ADDENDUM NO. 0C

Date: 05/11/2022

**Project: Bid NO. 455-2B
Shade Structures at Various Sites Group 2B**

SITE PLAN AND KEYED NOTES
 SHADE STRUCTURE AT EARL WARREN
 ELEMENTARY SCHOOL
 SACRAMENTO CITY UNIFIED SCHOOL DISTRICT
 SACRAMENTO, CA
 DSA APP. 02-120000

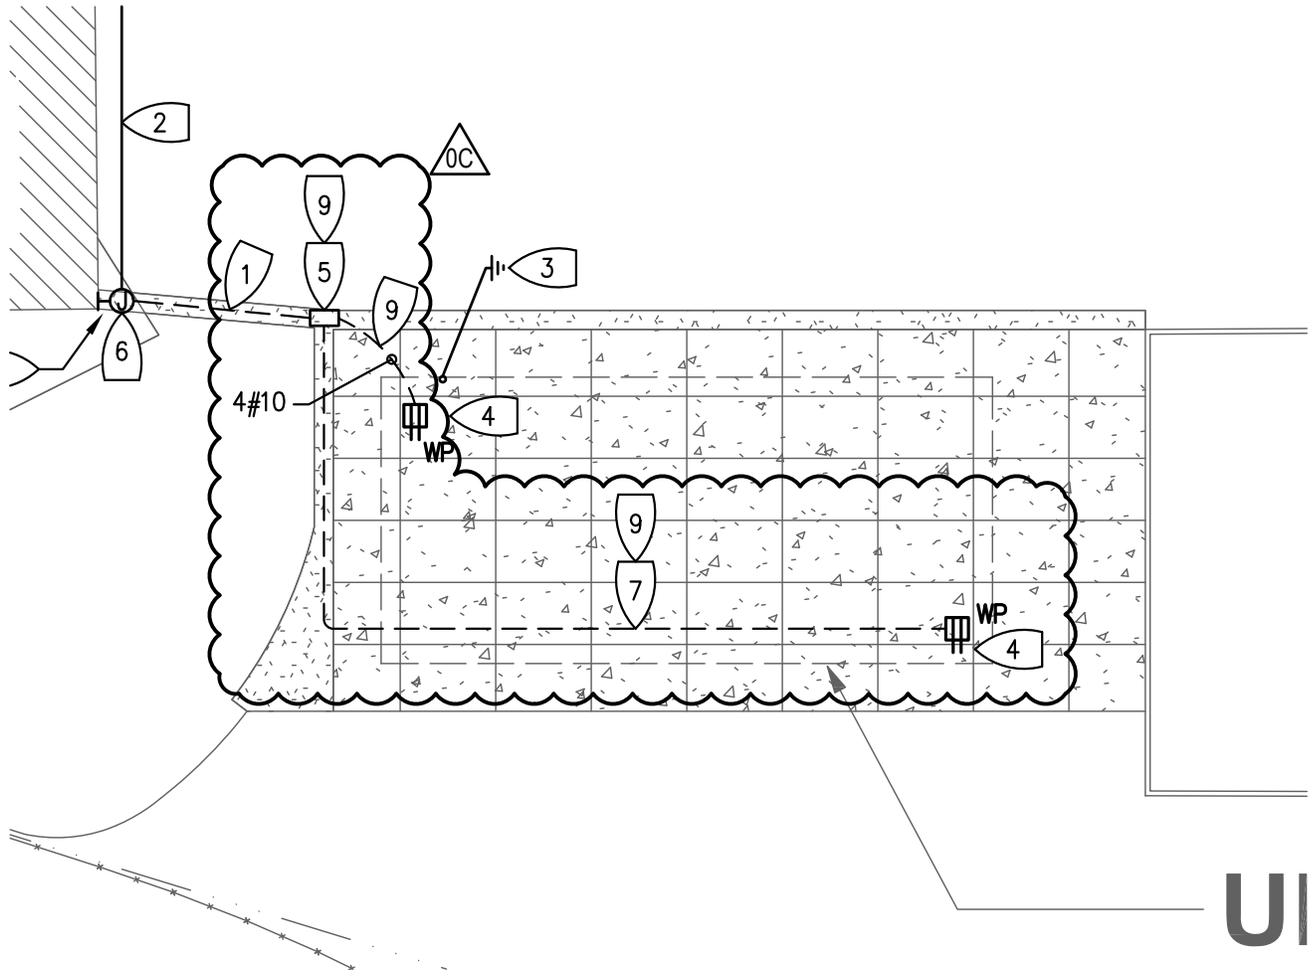
AD0C.03 Earl Warren ES DSA# 02-120000, Drawing Sheet E1.1 SITE PLAN – ELECTRICAL:

REVISE Drawing Sheet E1.1 SITE PLAN – ELECTRICAL per Attachment AD0C.13

- Conduit and gnd conductor scope and all applicable callouts revised.
- Keyed Note 4 revised
- Keyed Note 9 added

4 LOCKABLE, WEATHERPROOF RECEPTACLE TO HAVE A SINGLE-GANG METAL CUT-IN BACK BOX WITH 2-5/8" DEPTH AND 1" THREADED PORT(S). MOUNT RECEPTACLES 36" ABOVE GRADE UNLESS SPECIFIED OTHERWISE. SEE DETAIL 4/E3.1. 0C

9 PROVIDE 4#10 + 1#10 GND CONDUCTORS FROM PULL BOX TO FIRST SHADE STRUCTURE RECEPTACLE. PULL 2#10 + 1#10 GND CONDUCTORS FROM FIRST RECEPTACLE BACK TO PULL BOX THEN TO SECOND RECEPTACLE. CONDUCTORS TO SHARE 1" CONDUIT. DO NOT SPLICE IN PULL BOX. 0C

SITE PLAN AND KEYED NOTES
 SHADE STRUCTURE AT ELDER CREEK
 ELEMENTARY SCHOOL
 SACRAMENTO CITY UNIFIED SCHOOL DISTRICT
 SACRAMENTO, CA
 DSA APP. 02-120002

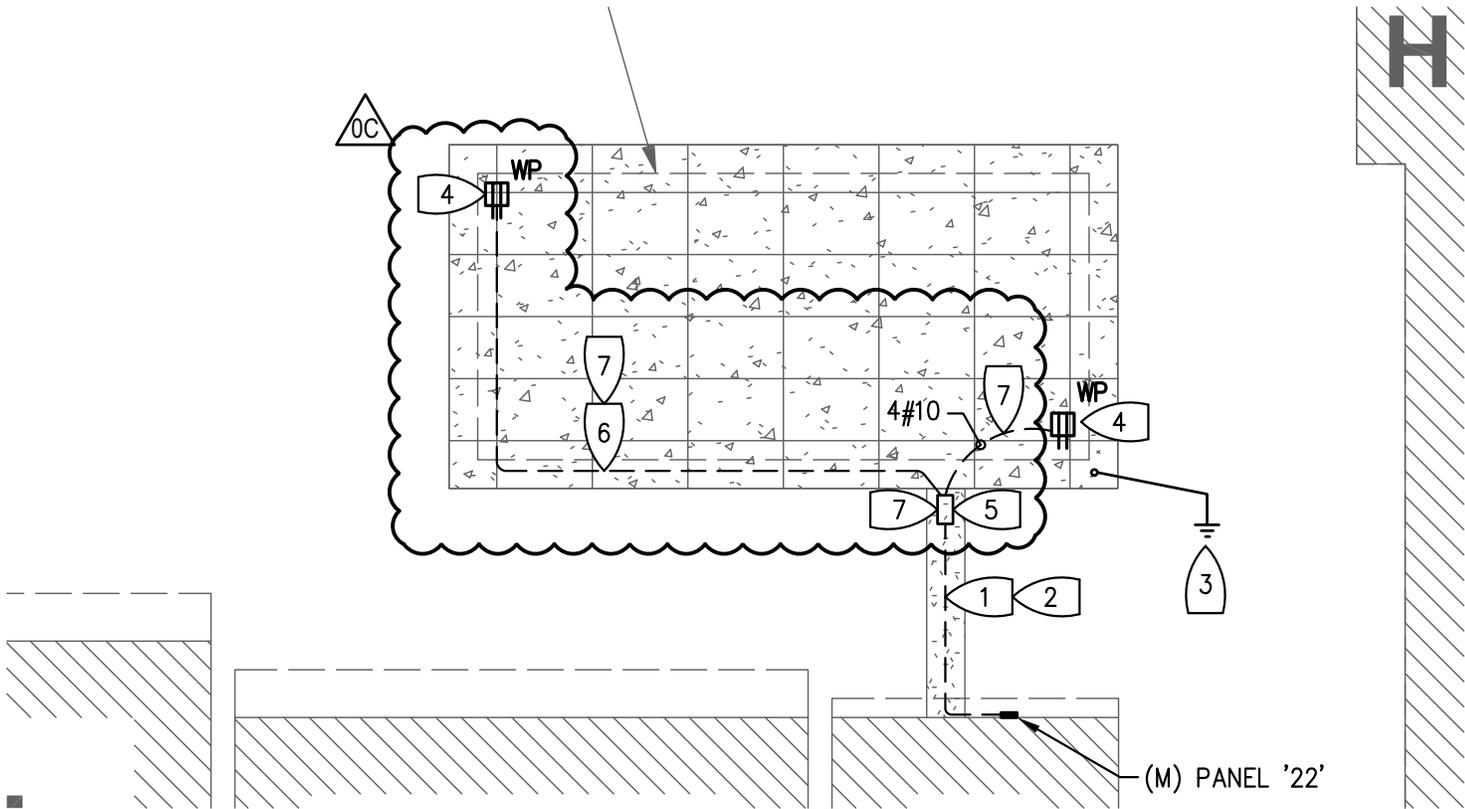
AD0C.05 Refer to Elder Creek ES DSA# 02-120002 Drawing Sheet E1.1 SITE PLAN – ELECTRICAL:

REVISE Drawing Sheet E1.1 SITE PLAN – ELECTRICAL per Attachment AD0C.14.

- Conduit and gnd conductor scope and all applicable callouts revised.
- Keyed Note 4 revised.
- Keyed Note 9 added.

4 LOCKABLE, WEATHERPROOF RECEPTACLE TO HAVE A SINGLE-GANG METAL CUT-IN BACK BOX WITH 2-5/8" DEPTH AND 1" THREADED PORT(S). MOUNT RECEPTACLES 36" ABOVE GRADE UNLESS SPECIFIED OTHERWISE. SEE DETAIL 4/E3.1. 0C

9 PROVIDE 4#10 + 1#10 GND CONDUCTORS FROM PULL BOX TO FIRST SHADE STRUCTURE RECEPTACLE. PULL 2#10 + 1#10 GND CONDUCTORS FROM FIRST RECEPTACLE BACK TO PULL BOX THEN TO SECOND RECEPTACLE. CONDUCTORS TO SHARE 1" CONDUIT. DO NOT SPLICE IN PULL BOX. 0C

SITE PLAN AND KEYED NOTES
 SHADE STRUCTURE AT MARK TWAIN
 ELEMENTARY SCHOOL
 SACRAMENTO CITY UNIFIED SCHOOL DISTRICT
 SACRAMENTO, CA
 DSA APP. 02-120006

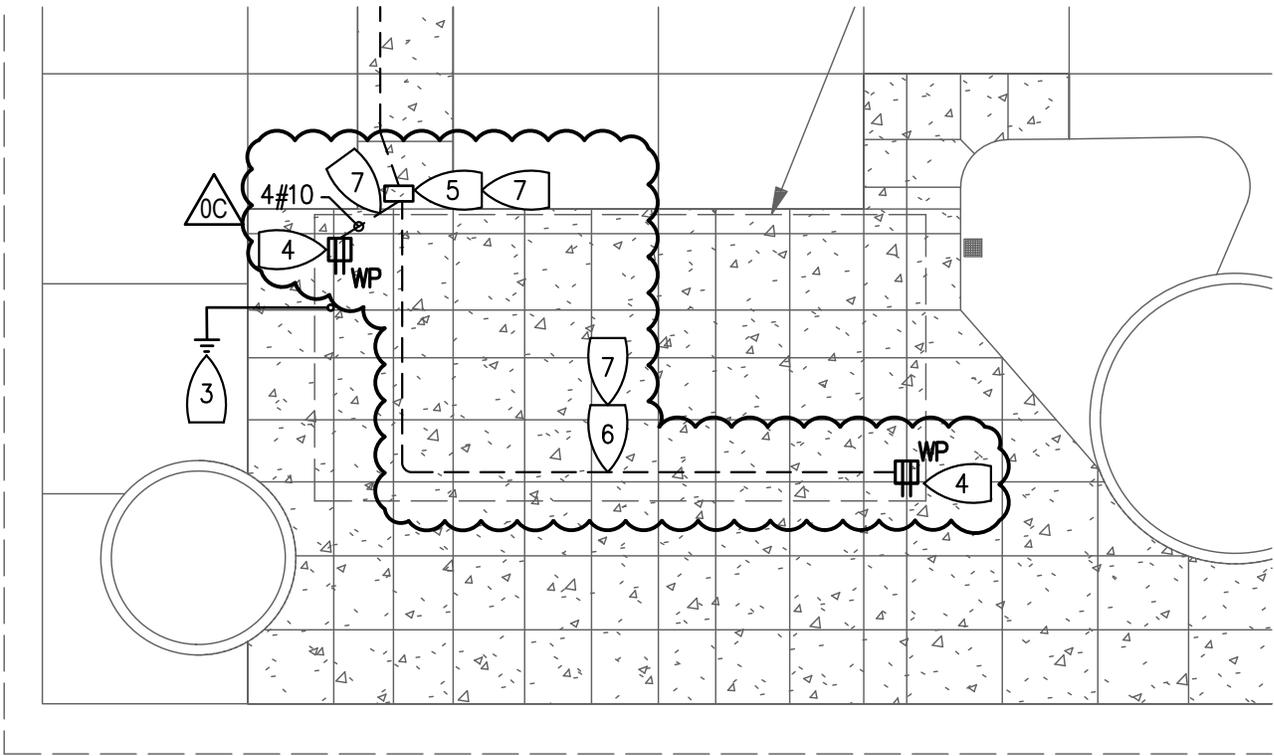
AD0C.07 Refer to Mark Twain ES DSA# 02-120006 Drawing Sheet E1.1 SITE PLAN – ELECTRICAL:

REVISE Drawing Sheet E1.1 SITE PLAN – ELECTRICAL per Attachment AD0C.15.

- Conduit and gnd conductor scope and all applicable callouts revised.
- Keyed Note 4 revised.
- Keyed Note 7 added.

4 LOCKABLE, WEATHERPROOF RECEPTACLE TO HAVE A SINGLE-GANG METAL CUT-IN BACK BOX WITH 2-5/8" DEPTH AND 1" THREADED PORT(S). MOUNT RECEPTACLES 36" ABOVE GRADE UNLESS SPECIFIED OTHERWISE. SEE DETAIL 4/E3.1.

7 PROVIDE 4#10 + 1#10 GND CONDUCTORS FROM PULL BOX TO FIRST SHADE STRUCTURE RECEPTACLE. PULL 2#10 + 1#10 GND CONDUCTORS FROM FIRST RECEPTACLE BACK TO PULL BOX THEN TO SECOND RECEPTACLE. CONDUCTORS TO SHARE 1" CONDUIT. DO NOT SPLICE IN PULL BOX.

SITE PLAN AND KEYED NOTES
 SHADE STRUCTURE AT ROSA PARKS MIDDLE SCHOOL
 SACRAMENTO CITY UNIFIED SCHOOL DISTRICT
 SACRAMENTO, CA
 DSA APP. 02-120007

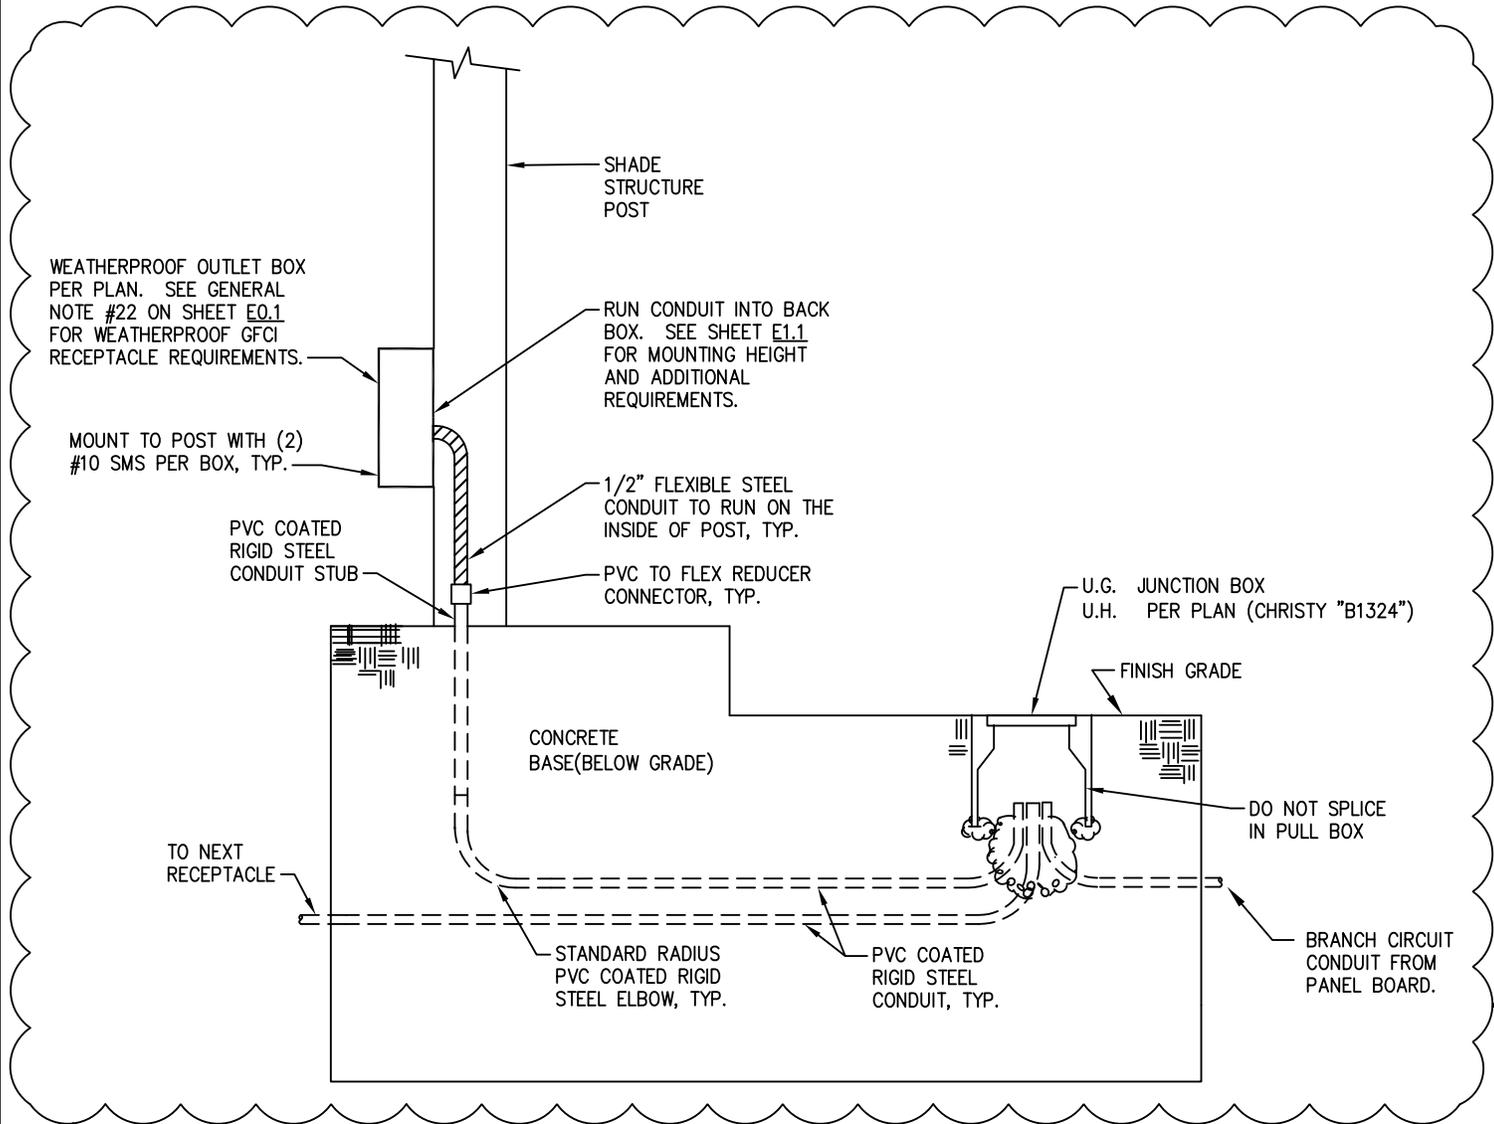
AD0C.09 Refer to Rosa Parks MS DSA# 02-120007 Drawing Sheet E1.1 SITE PLAN – ELECTRICAL:

REVISE Drawing Sheet E1.1 SITE PLAN – ELECTRICAL per Attachment AD0C.16.

- Conduit and gnd conductor scope and all applicable callouts revised.
- Keyed Note 4 revised.
- Keyed Note 7 revised.

4 LOCKABLE, WEATHERPROOF RECEPTACLE TO HAVE A SINGLE-GANG METAL CUT-IN BACK BOX WITH 2-5/8" DEPTH AND 1" THREADED PORT(S). MOUNT RECEPTACLES 36" ABOVE GRADE UNLESS SPECIFIED OTHERWISE. SEE DETAIL 4/E3.1. 0C

7 PROVIDE 4#10 + 1#10 GND CONDUCTORS FROM PULL BOX TO FIRST SHADE STRUCTURE RECEPTACLE. PULL 2#10 + 1#10 GND CONDUCTORS FROM FIRST RECEPTACLE BACK TO PULL BOX THEN TO SECOND RECEPTACLE. CONDUCTORS TO SHARE 1" CONDUIT. DO NOT SPLICE IN PULL BOX. 0C
